Addendum Number Five
To The Drawings and Specifications for
EMS Post #1
RFB Bid Number: 26-0035, Sedgwick County, Kansas

Issued: September 22, 2026

You are hereby instructed to include in your bids the following changes and/or corrections to the Drawings and Specifications for the **Construction of the New EMS Post #1 – 3099 W. 13th Street North, Wichita, Kansas 67203.**

SHEET
A6.1
OF 1 SHEETS

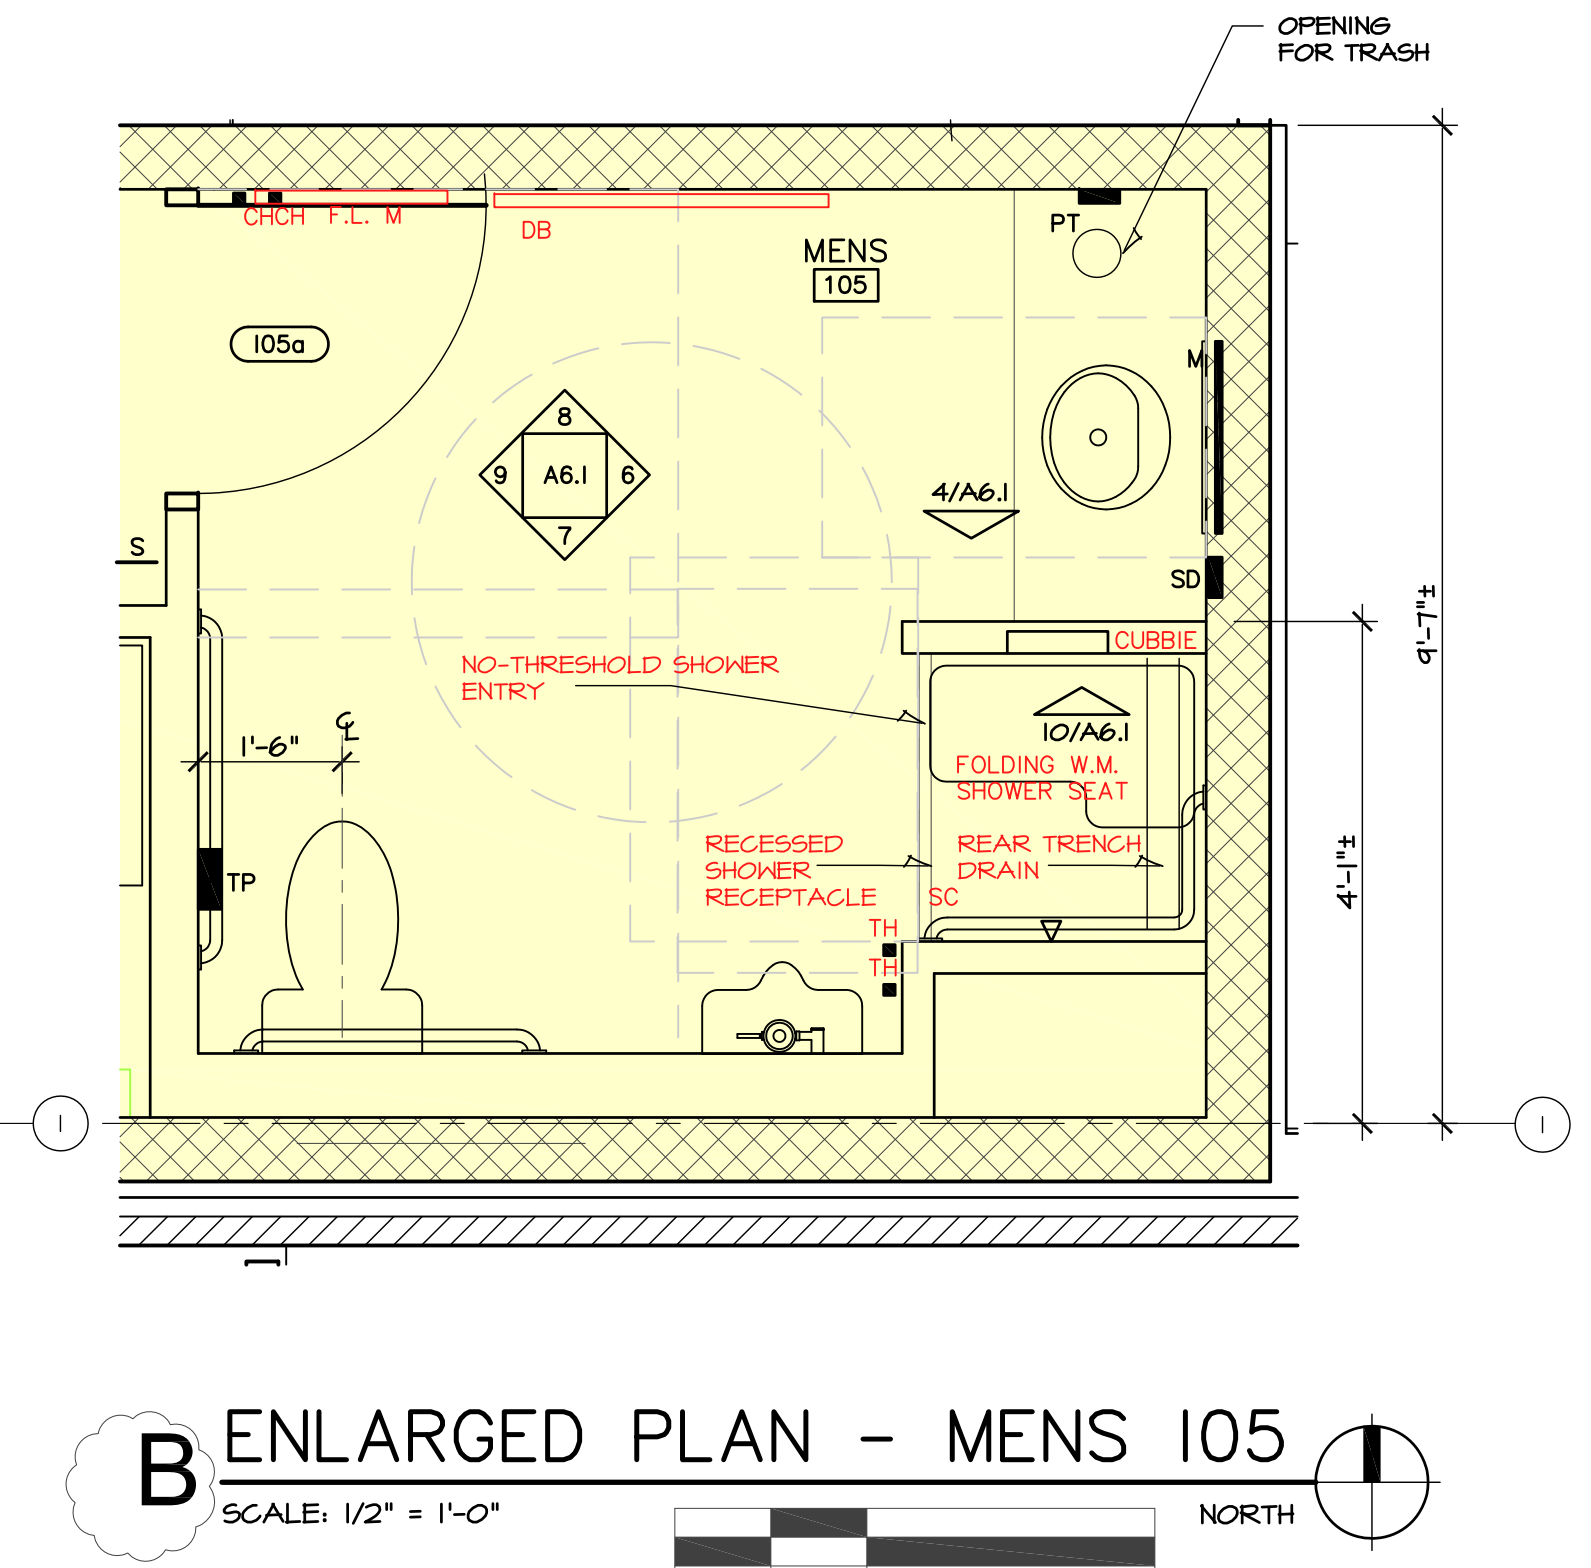
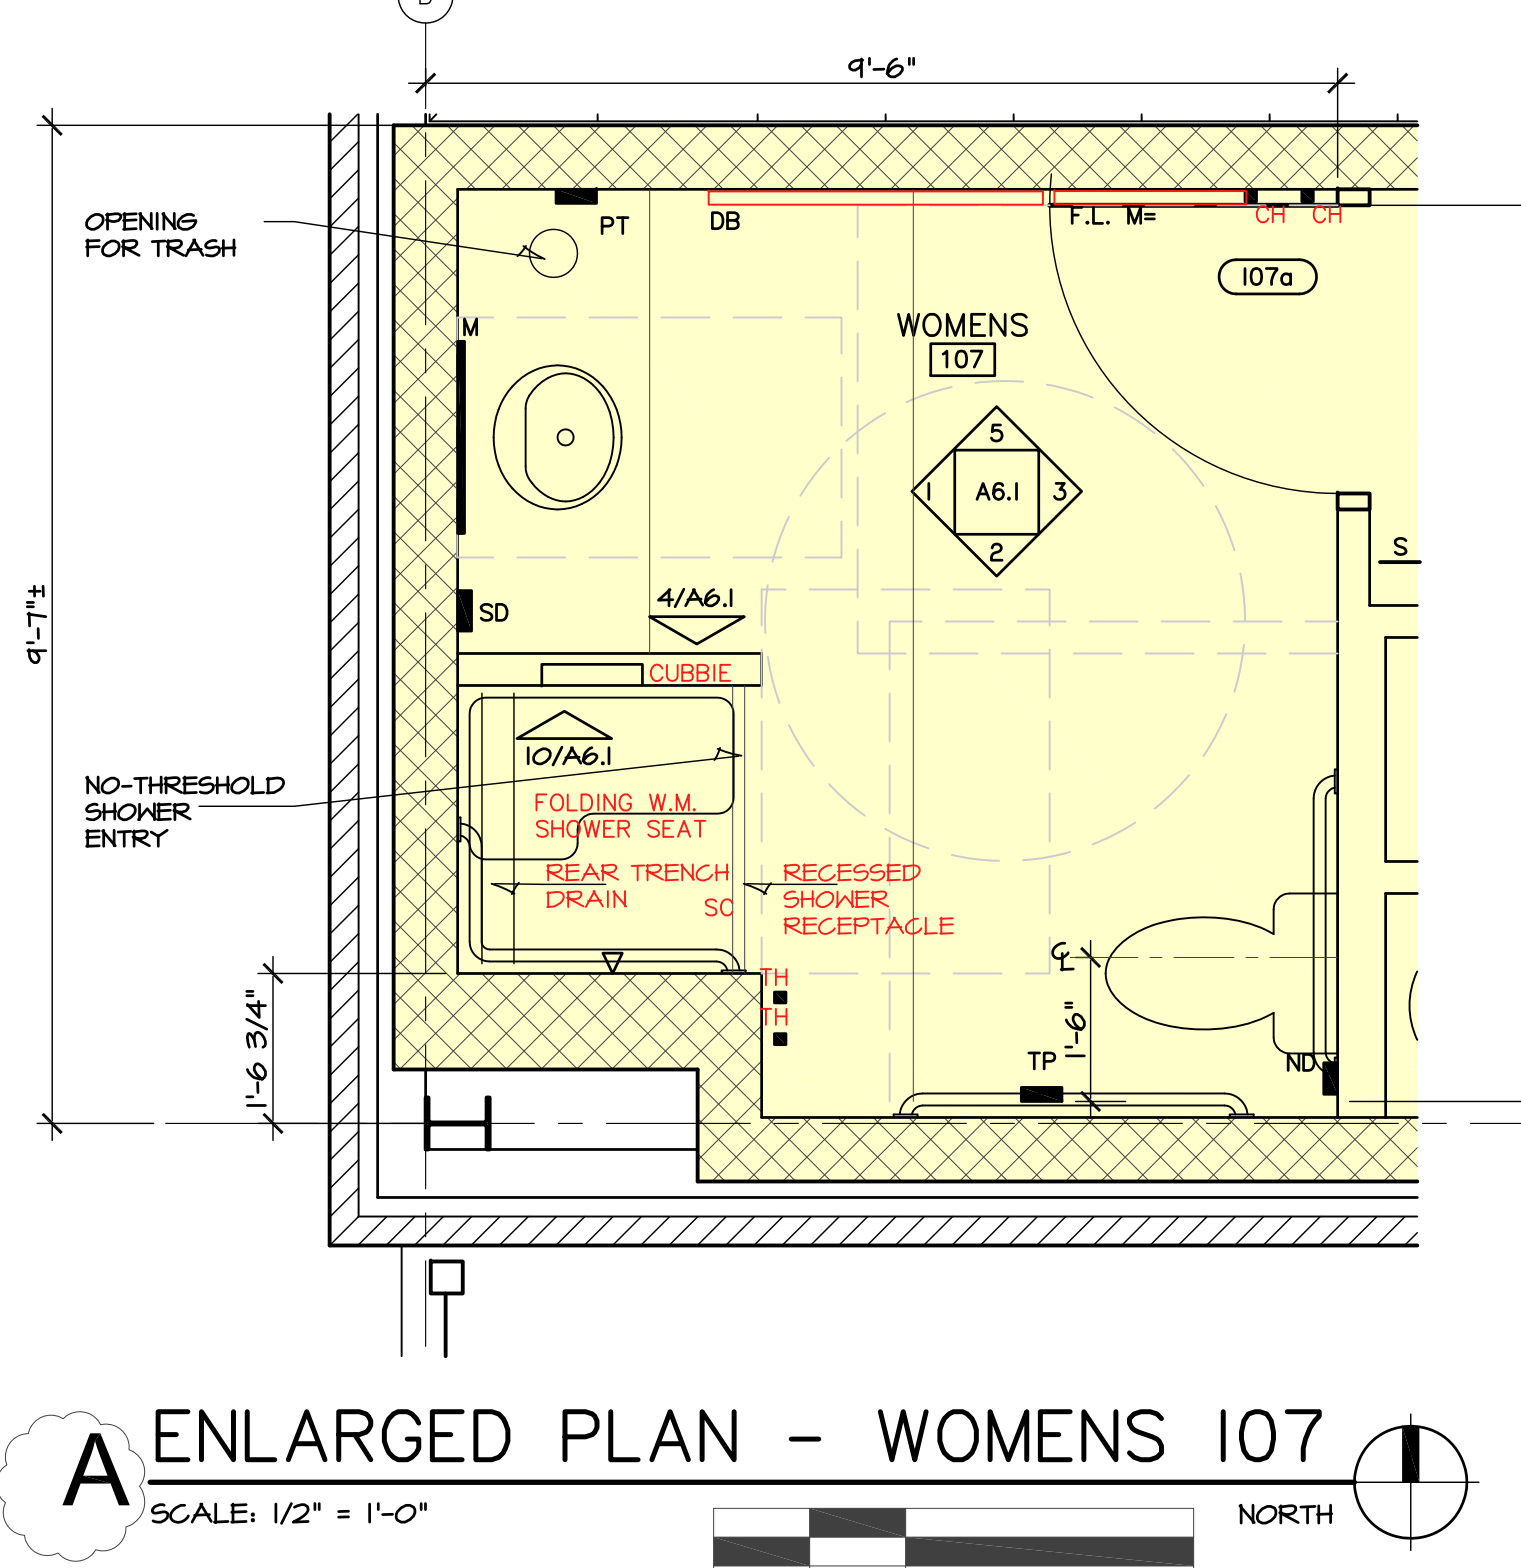
- d. Add sub-paragraph 9.3. – Tile Product, Restroom walls.
 1. Refer to the revised Sheet A6.1 issued with this addendum.
 2. Basis of Design, Metallic look Porcelain, Square format (field cut to size) or approved equal.

Distributor: Arizona Tile, Contact: Bobby Zink, phone (303) 574-2990,
email: bzink@arionatile.com
 3. Product is a rectangular sized tile,
Product: Reflexion (Reflex). Field Color: Mercury. Size: 12 inches x 24 inches.
Finish: Metallic sheen. Include matching porcelain bullnose trim, apply to exposed edges. Bullnose size 3 x 12. Installation is horizontally staggered. Color and install for bidding purposes, verify with architect prior to ordering.
 4. Schluter Metal trim applied to floor/ base joint. See detail 6/A8.1.
 5. Wall tile wainscot height as noted, 4 feet 9 inches. Field Tile: Start full sized tiles above floor/base joint. (4) full height courses. Accent Color, Continuous Horizontal Band, for Top (2) courses as follows: Cut tile height plus bull nose trim tile. Accent color: Titanium.
 6. Shower walls are as noted on A6.1, A8.2 and A8.3, issued by this addendum.

- 3.9 Sheet A6.1 + A6.2
The shower and finishes have been corrected.
These sheets are being reissued with this addendum.
- 3.10 Sheet A8.2 + Sheet A8.3
These sheets are being reissued with this addendum, detailing the shower.
